AKH Stitch Art Ltd.

07 May 2014

Building Observations

Drawing inconsistencies

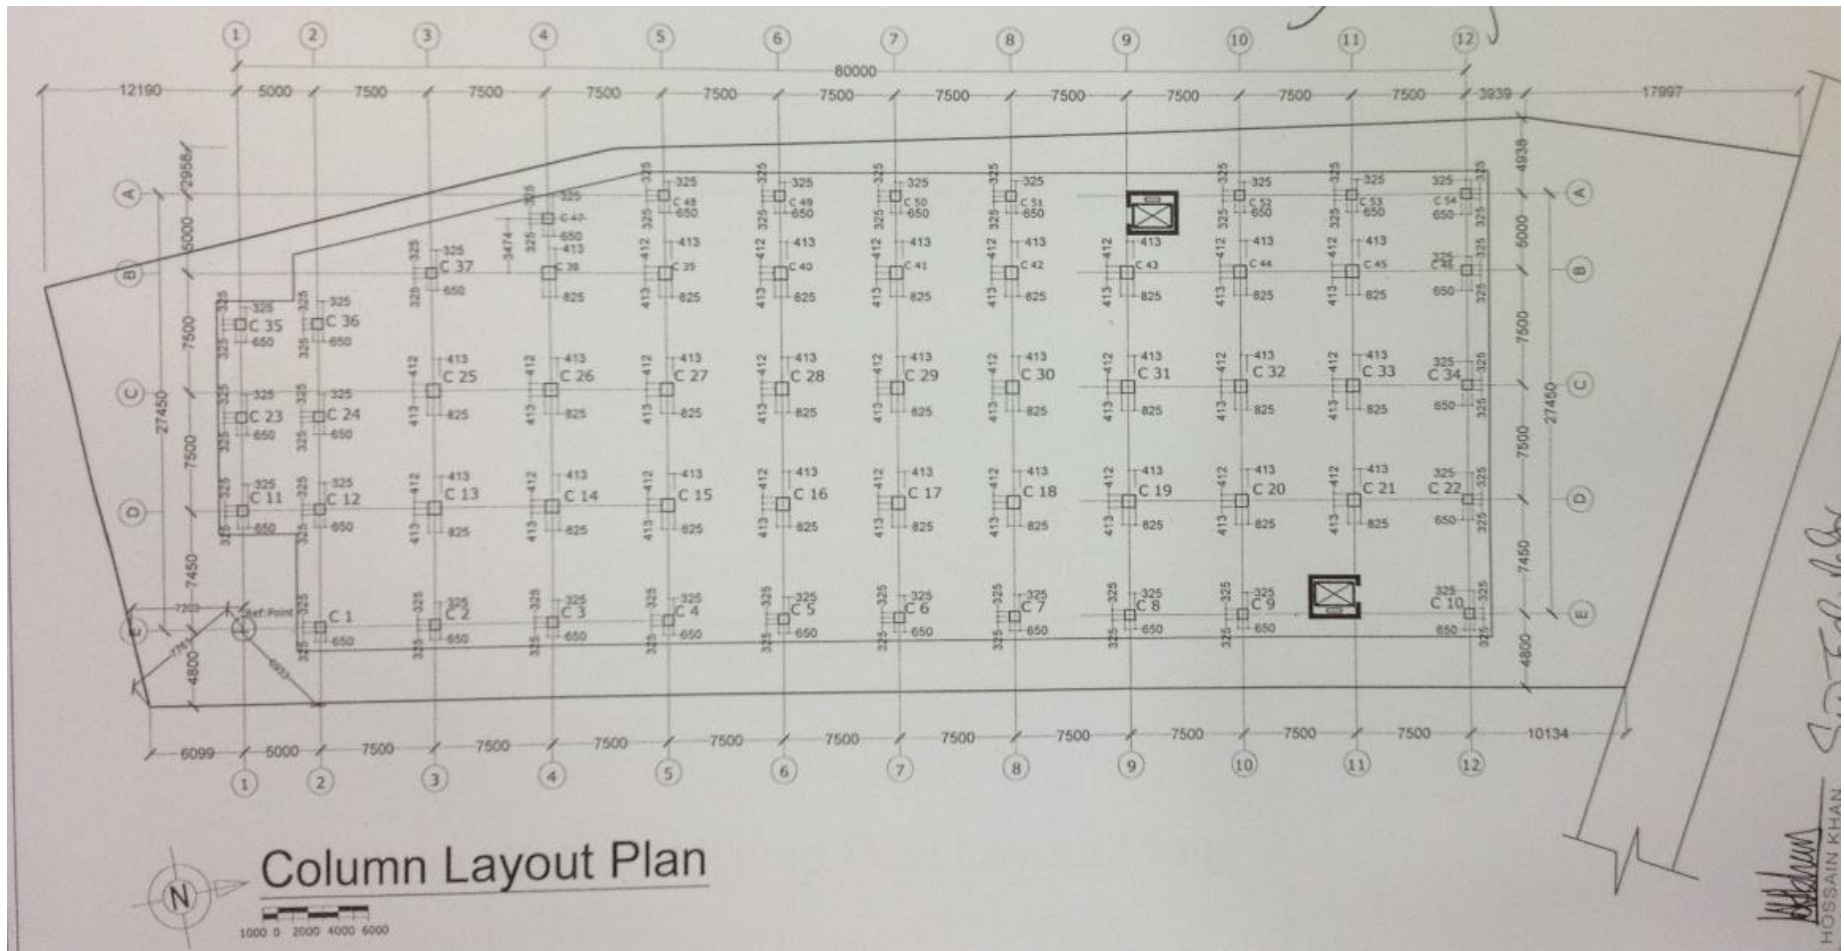
Structural drawings not consistent with the as-constructed arrangement of the factory

- Constructed columns smaller than indicated on the structural drawings.
- Building engineer to survey and update drawings as required.

5	Structural drawings not consistent with the as-constructed arrangement of the factory	Building Engineer to survey as-constructed building and update drawings as required.	6-months
6	Non-engineered structures	Building Engineer to verify capacity and connections of the roof structure to the dining area and the link-bridge	6-months
7	Non-engineered structures	All required strengthening works to be completed.	6-months

Localised areas of high loading

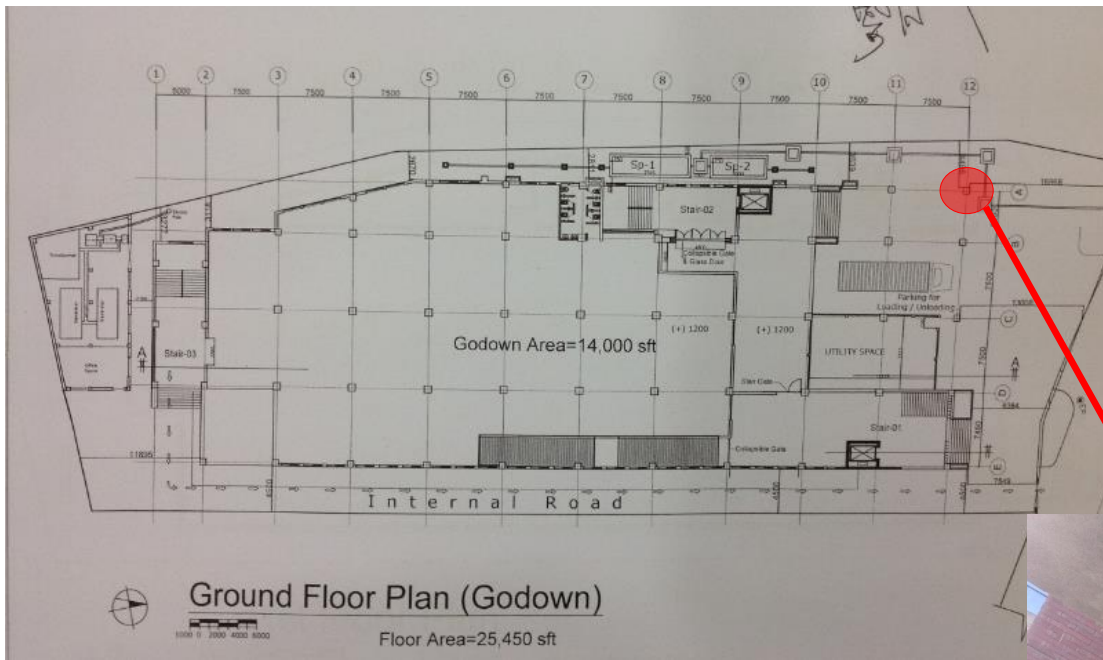
- Uncontrolled stacking of materials observed.
- No load management system in place.

Exposed reinforcement

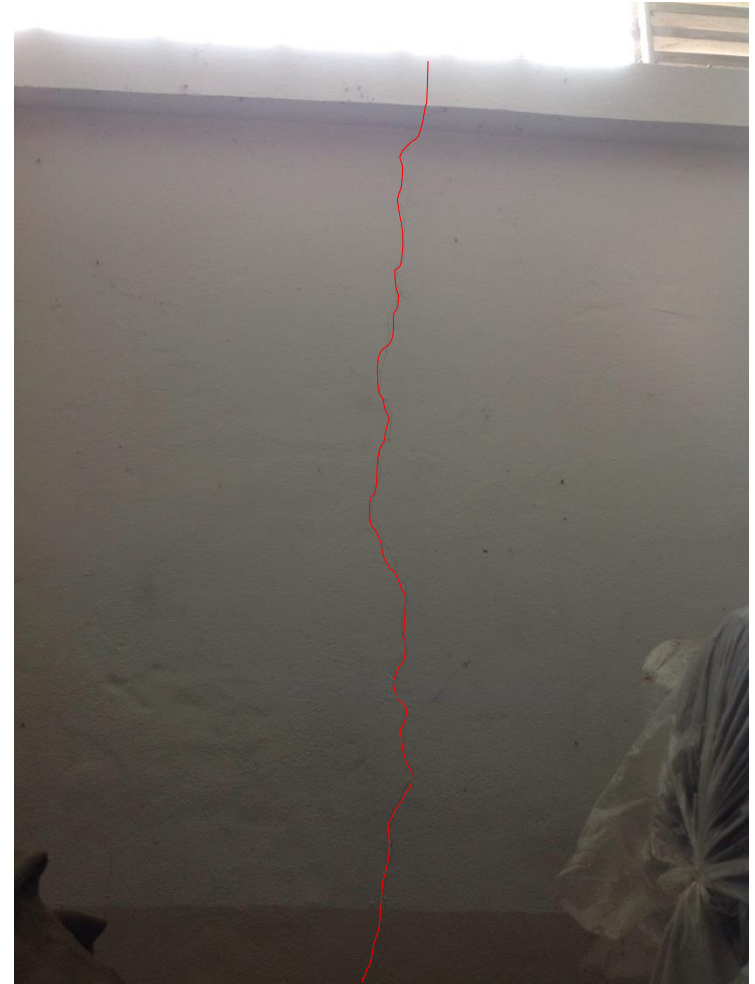
- Exposed reinforcement observed at front of building.
- Reinforcement should be protected and concrete repaired.
